**UNITED STATES NUCLEAR  
REGULATORY COMMISSION  
WASHINGTON D.C.**

## **Integrations to our previous application**

**List of the requested answers according to the points mentioned in your enclosure dated 22<sup>nd</sup>. April 2003. The whole revised application will be following per courier.**

**APPLICATION FOR REGISTRATION  
OF RADIATION DEVICE MODEL ISOSINT  
FOR RADIOACTIVE SOURCES Kr. 85 AND Sr. 90**

SURF.TREAT.							
THERM.TREAT.							
MATERIALS		MACHINE SCANNER - SINTEL9000					
DES.	TM	DESCRIPTION <b>ISOSINT PLAN VIEW</b>					
CHECKED	TM						
APPROVED	TF						
HD ARCHIVE							
 <b>Electronic SYSTEMS</b> S.p.a.					SCALE 1:2	DATE 12.03.03	F.TO A4
	DWG.NO				<b>U.S. 1001</b>		REV. -

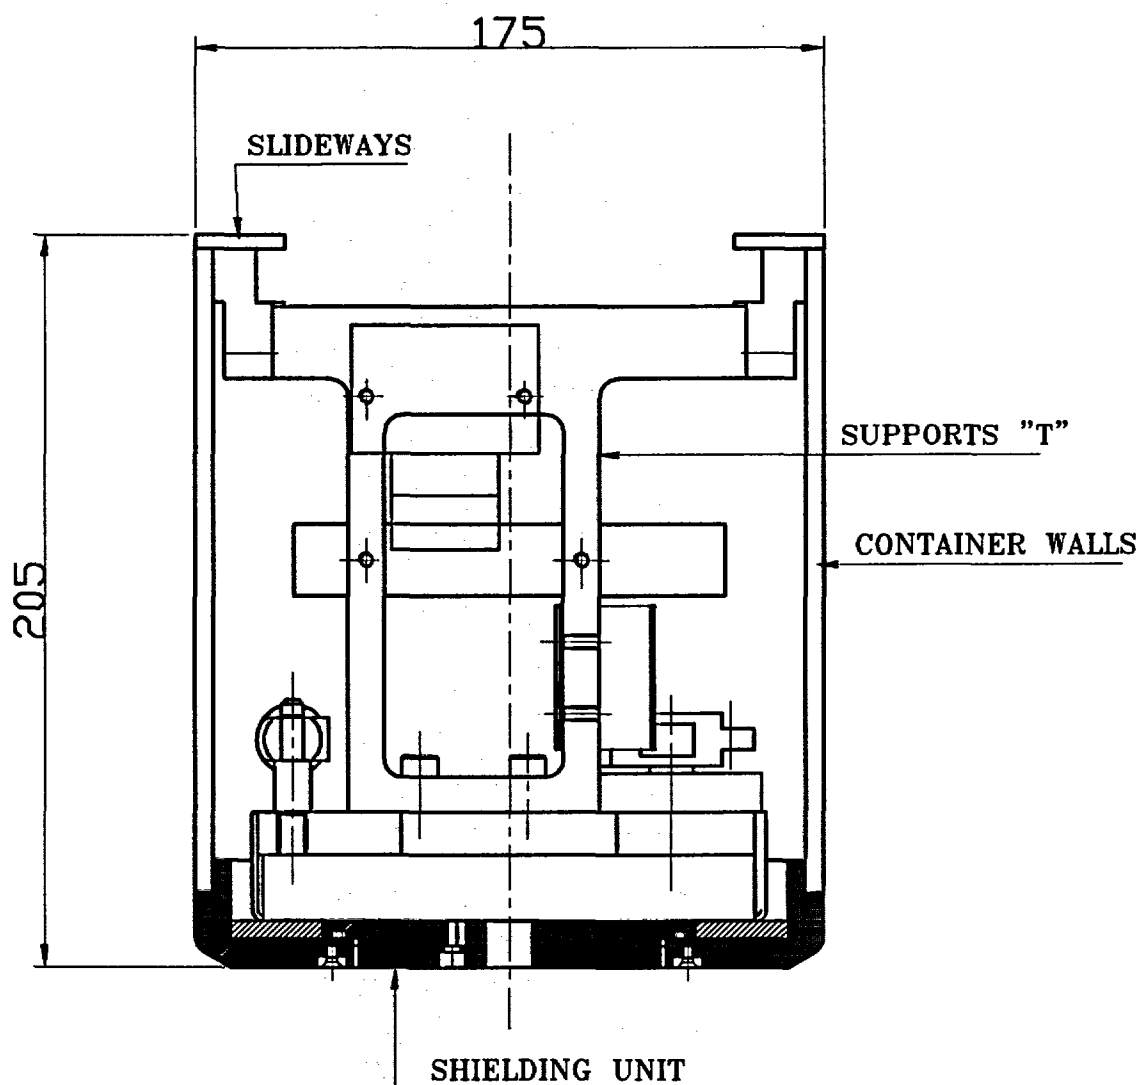
As requested we have revised engineering drawings **US 1001** and **US 1002** and indicated the overall dimensions of the gauge (see enclosure); we provide also the revised engineering drawing n. **US 1009** where we have eliminated the name Slim duplex 1700 and modified with the right name SINTEL 9000 according to the lists of enclosures (ref. Page 4 our application) (see enclosure); concerning the engineering drawing n. **US 1004** we have sent you a drawing for Strontium 90 and not Krypton 85; in any case, we provide also the missing drawing **US 1004A**.

## RADIATION PROFILE -

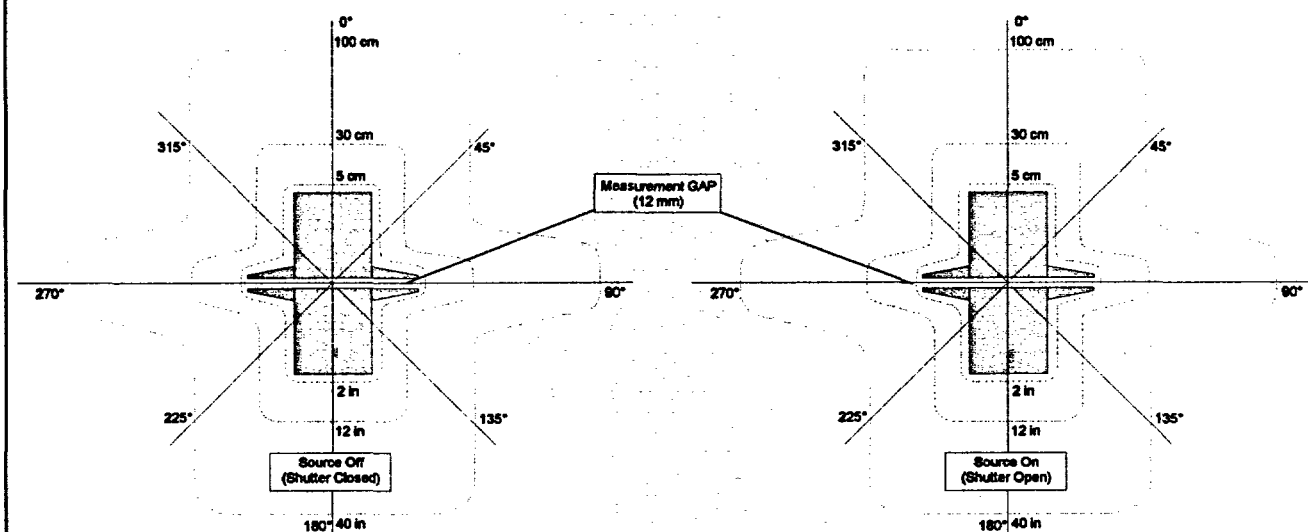
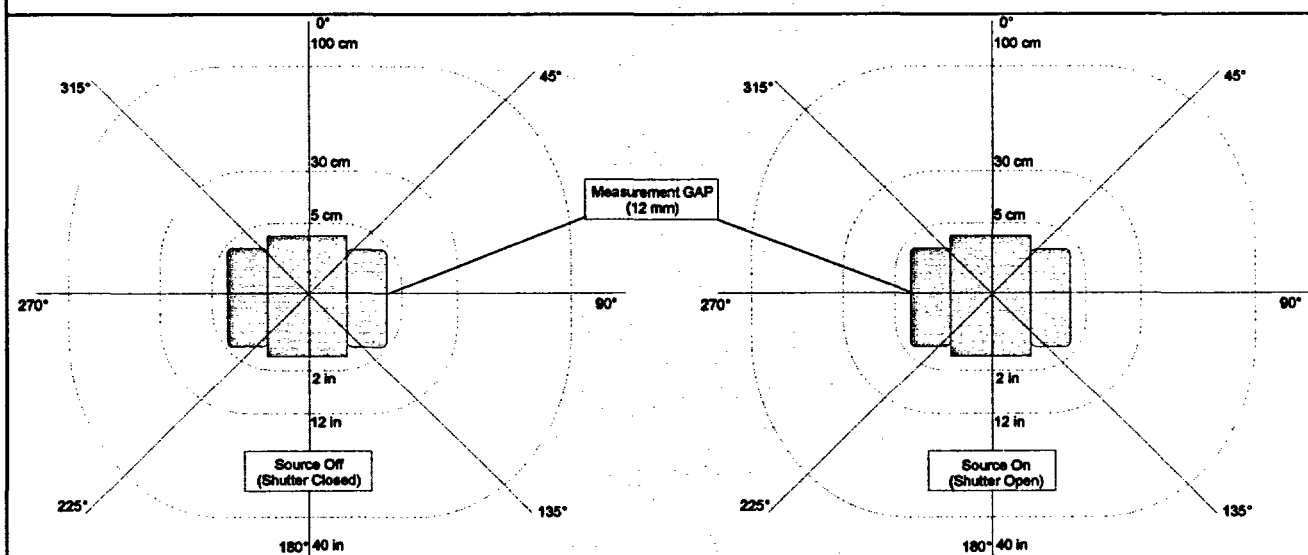
Attached you will find the "Radiation profile" data sheets prepared for both Kr-85 and Sr-90, considering distances of 5, 30, and 100 cm with the shutter open and closed.
